COMMUNITY DEVELOPMENT

DEPARTMENT REPORT

SUBJECT: Pine 43 Mixed Use Subdivision – ALT,

H-2024-0071

I. Conceptual Development Plan & Existing and Future Building Elevations – HPC Buyer Property

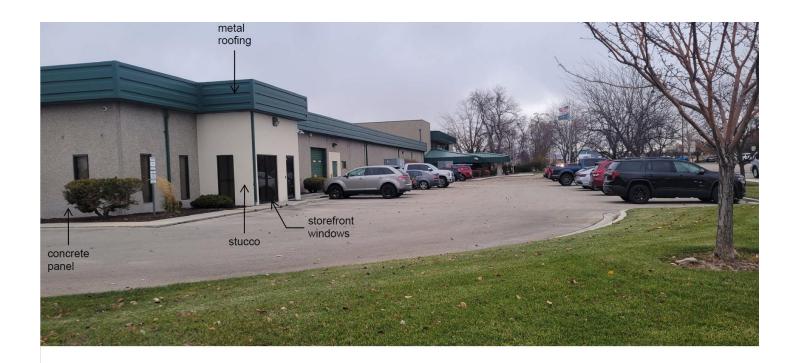
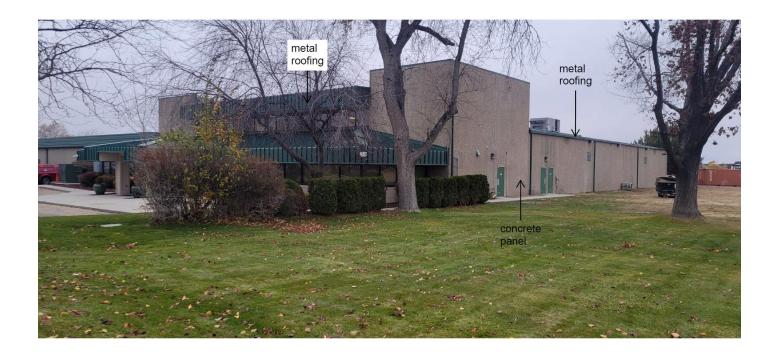
Photos of the existing building on the HPC Buyer property and a conceptual perspective drawing and elevations have been submitted for the future expansion, included below in Section VII.I. Upgrades are planned to the existing building with the expansion to tie in with the new portion(s). Final design is required to comply with the design standards in the Architectural Standards Manual.

COVER SHEET - PINE 43 MIXED USE - SITE AND LANDSCAPE PLANS

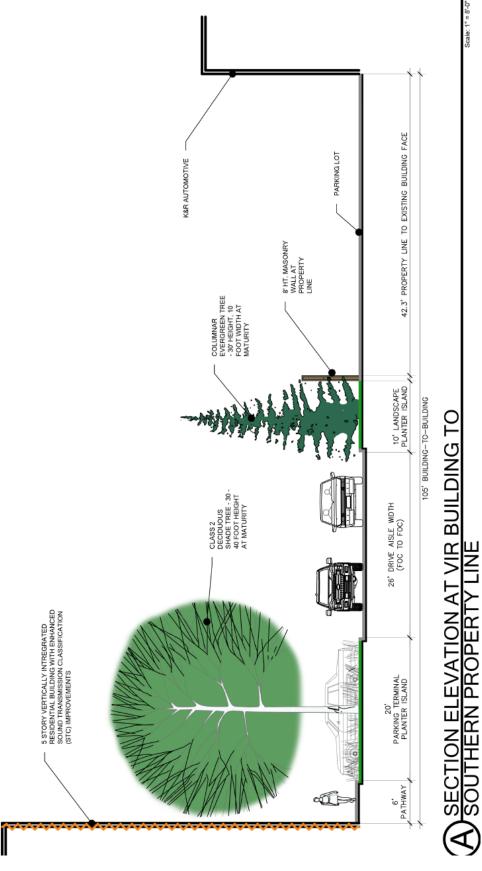
Additionally, it's Staff's opinion the vertically integrated residential use on Lot 1, Block 1 is not compatible with adjacent industrial uses and operations to the south. Industrial operations typically produce impacts such as noise, vibration, light pollution, and emissions, which can negatively affect the health, safety, and overall livability of nearby residential environments. Therefore, Staff recommends the concept master plan is revised to reflect

N. Overall Open Space Exhibit & Calculations – REVISED

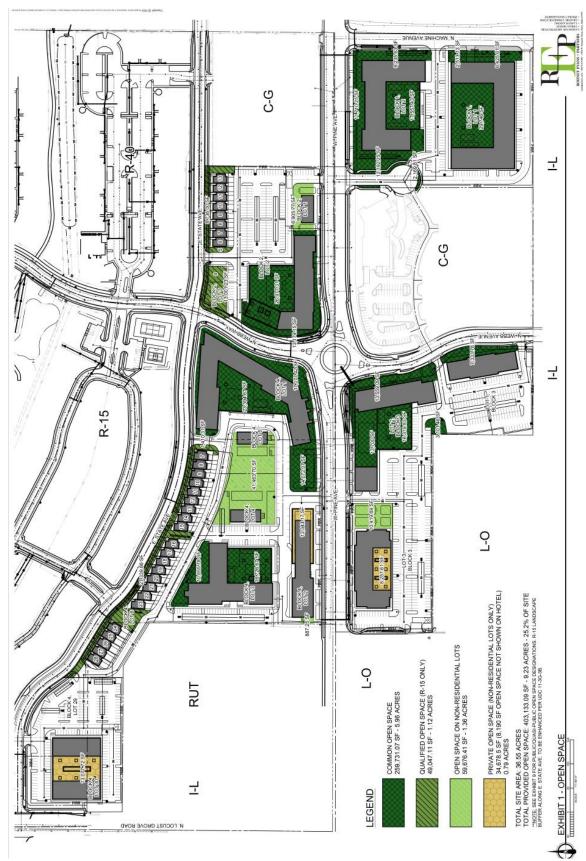
- The exhibit in Section VII.N depicts open space on non-residential lots but appears to include portions of the street buffers along Pine Ave. on Lot 3, Block 3 and Lot 2, Block 4, and Lot 1, Block 2, which should not be included. Staff recommends a revised open space exhibit is submitted prior to the City Council hearing that excludes street buffers with details of the public/quasi public spaces and places with amenities, landscaping, pathways, etc. A revised open space exhibit was submitted along with renderings of public-quasi-public spaces and places with amenities (see exhibit below in Section BB).

appear to be in the street buffer along Pine Ave. and do not qualify as noted above. A revised open space exhibit should be submitted that excludes these areas, that demonstrates compliance with the minimum area, and includes more details.
